MILITARY SPECIFICATION

SEMICONDUCTOR DEVICE, THYRISTORS, (CONTROLLED RECTIFIERS) SILICON

TYPES 2N2024, 2N2025, 2N2027, 2N2029, 2N2030

This amendment forms a part of Military Specification MIL-S-19500/203C(NAVY), dated 9 March 1970, and is approved for use by all Departments and Agencies of the Department of Defense.

FIGURE 2. Dimensions of controlled rectifier, types 2N2024, 2N2025, 2N2027, 2N2029, and 2N2030.

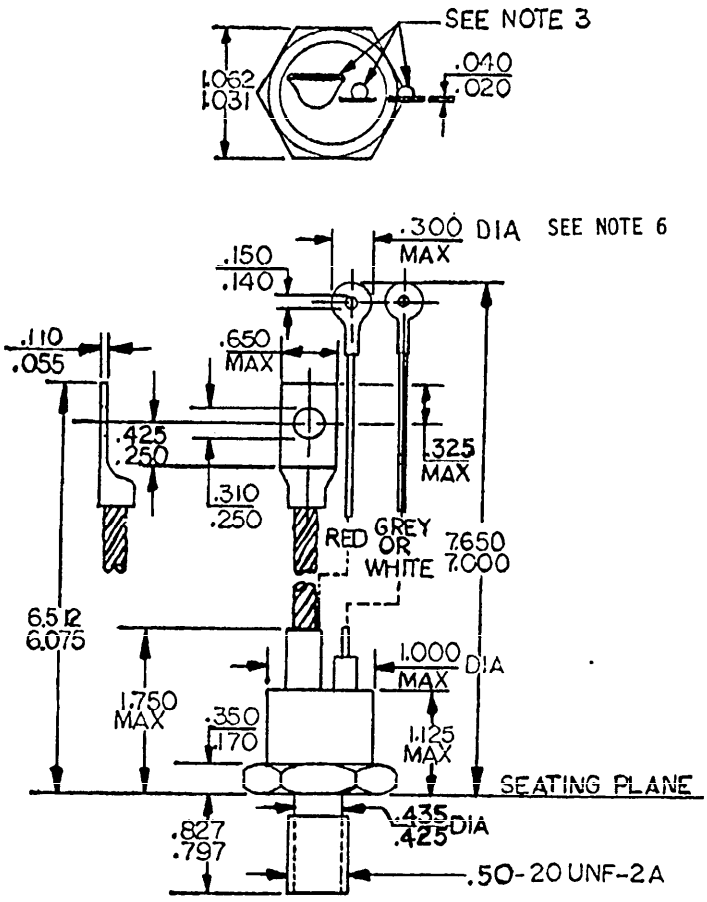
* Delete figure 2 and substitute now figure 2 as printed on page 2 of this amendment.
